UNITED STATES PATENT AND TRADEMARK OFFICE

APPLICATION NO.	FILING DATE	FIRST NAMED INVENTOR	ATTORNEY DOCKET NO.	CONFIRMATION NO.
10/802,563	03/17/2004	Hong Yu Yu	NUS03-001	3494

Office Action Summary

FIG. 3J
(PRIOR ART)

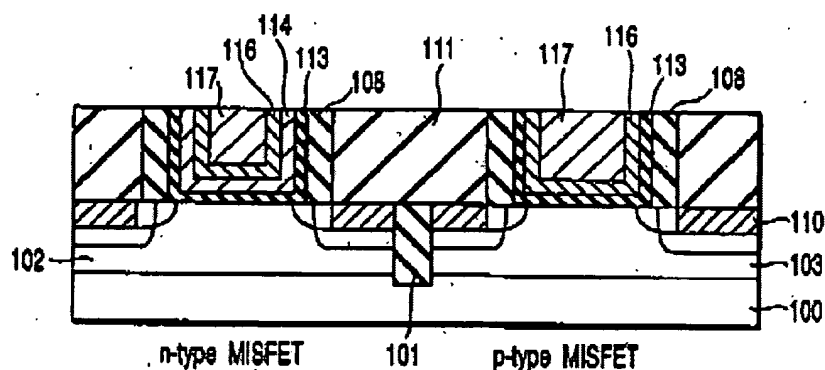
Matsuo discloses a method of fabricating semiconductor device as claimed. **See all the FIGS** where Matsuo teaches the following limitations

1. Pertaining to claim 8, discloses a method for fabricating a semiconductor device structure comprising:

providing a dielectric layer **113** on a substrate **100**;

depositing a hafnium nitride layer **114** overlying said dielectric layer **113**;

depositing a capping layer **116 & 117** overlying said hafnium nitride layer **114**;

patterning said hafnium nitride layer **114** and said capping layer **116 & 117** and said dielectric layer **113** to form a gate and forming source and drain regions **109** within said substrate **100** adjacent to said gate electrode.

3. Pertaining to claim 24, The method according to Claim 17 further comprising, depositing a second metal capping layer **116 & 117** overlying said first metal layer **114** prior to said patterning wherein said second metal is different from said first metal (please note a first metal layer is hafnium nitride and a second metal is tantalum nitride).

4. Pertaining to claim 26, The method according to Claim 24 wherein said first metal layer comprises hafnium nitride **114** and wherein said second metal layer comprises tungsten or tantalum nitride **116**.
